REVIEW OF:

***Preliminary Draft: Status of Volcanic Hazard Studies for The
Yucca Mountain Site Characterization Project,
Dated February 1993***

**Center for Nuclear Waste Regulatory Analyses
San Antonio, Texas**

July 1993

Figure 2-1. Lognormal (A) and normal (B) cumulative frequency plots of $^{40}\text{Ar}/^{39}\text{Ar}$ dates for Lathrop Wells by Turrin and Champion (1991). The large errors associated with these data preclude meaningful conclusions about the statistical distributions of this data set.

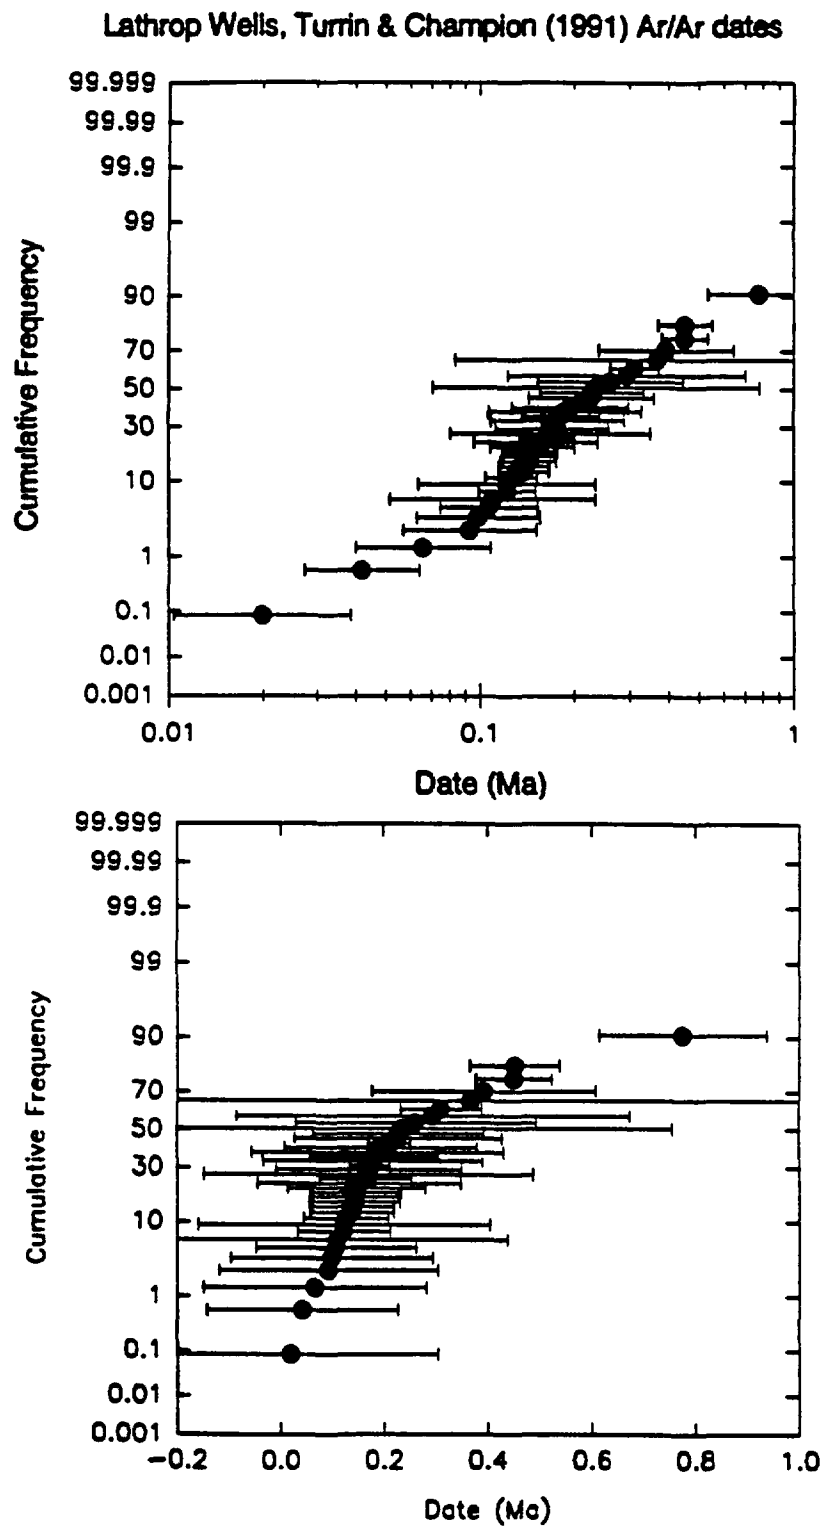
probability and box plots (Figures 2.13-2.16 Crowe et al, 1993) is questionable when the reported one sigma errors for published $^{39}\text{Ar}/^{40}\text{Ar}$ dates are plotted on similar figures (Figure 2-1).

In addition, the statistical tests used to identify anomalously old dates produced by contamination fail to incorporate analytical uncertainties. The significance of the four contaminated $^{39}\text{Ar}/^{40}\text{Ar}$ dates of Turrin and Champion (1991) is questionable when these data are plotted with reported analytical errors (Figure 2-2). The sample at 0.95 Ma is significantly older than the rest of the population, but it is not at all clear how two samples at 0.45 ± 0.09 Ma are distinctly contaminated yet samples at 0.39 ± 0.22 and 0.39 ± 0.64 Ma are not.

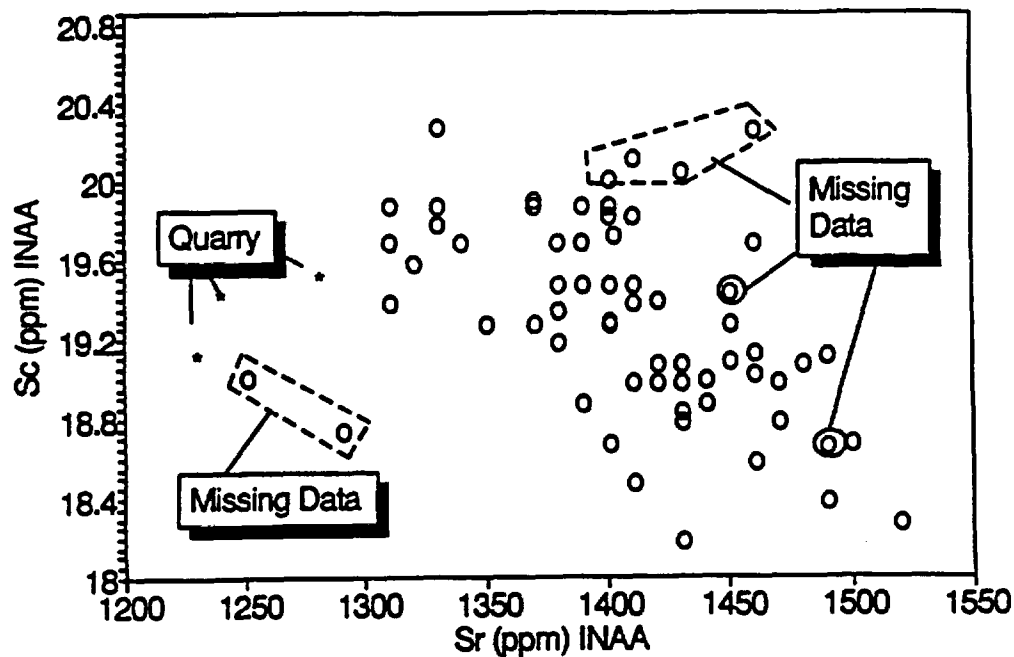
Perry and Crowe (1992) present preliminary data that shows some Lathrop Wells units may be compositionally distinct. Perry and Crowe (1992) and this report contend "that all the units cannot be derived from the same magma," and apparently test a closed-system fractionation hypothesis. With the exception of the Quarry unit, closed system fractionation is still a valid hypothesis for the trace element data presented. There is a small amount of variation within each unit, which is apparently related to small amounts analytical error. However, the scoria deposits for units Q₄ and Q₅ are at times compositionally distinct (i.e., beyond analytical error) from the associated lava flows. The magnitude of the presented interunit compositional distinctions is about the same as the magnitude of the presented intraunit compositional distinctions, with the exception of the Quarry unit. Within the range of analytical uncertainty reported in these figures, the removal of 3 percent plagioclase from these units would produce the observed compositional trends. Using the data presented, the Quarry unit may be the only Lathrop Wells unit that cannot be explained by a simple closed-system fractionation hypothesis.

Figure 4-1. Some Lathrop Wells analyses in print-out binder TWS-EES-13-LV-10-89-04 apparently are missing from plots of these data in Crower et al. (1993) and Perry & Crowe (1992). No criteria are presented to distinguish missing data from plotted data.

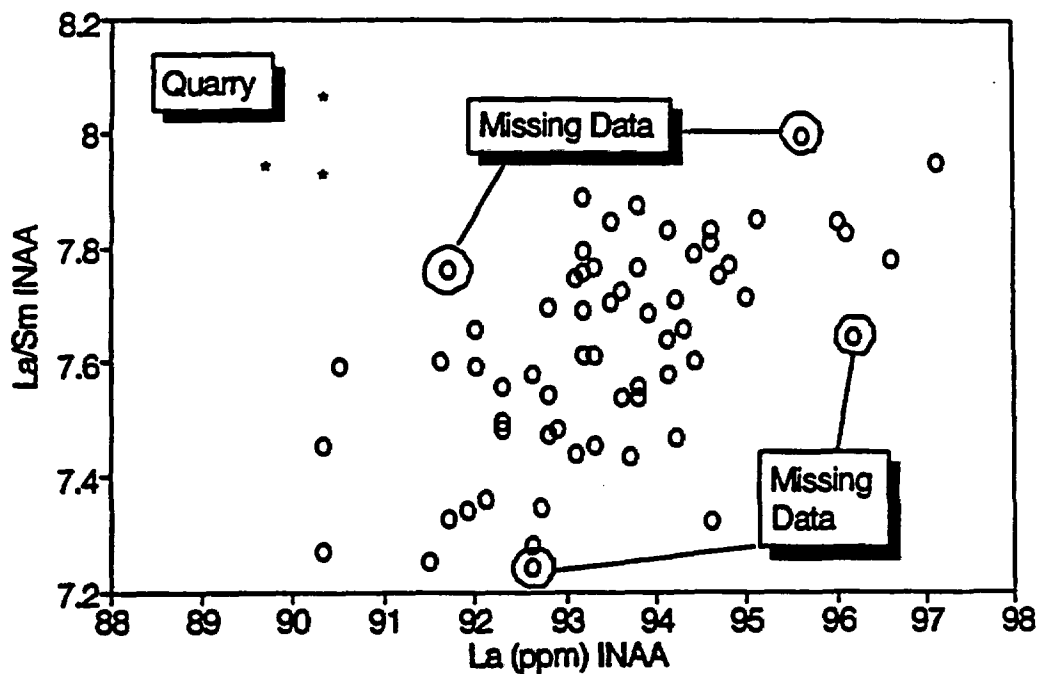
Basis: Over 100 geochemical samples have been collected by the authors at Lathrop Wells (p. 166), yet Figures 4.4 and 4.5 show only about 25 data points. Are the remaining 75 samples contained in the

stippled fields, or yet to be analyzed? Using the analyses of "LW" samples provided in the Los Alamos Project Volcanism Print-Out Binder TWS-EES-13-LV-10-89-04 (Perry and Crowe, 1992), there appears to be data missing from Figures 4.4 and 4.5 of Crowe et al. (1993) and Perry Crowe, (1992); compare with Figure 4.1.
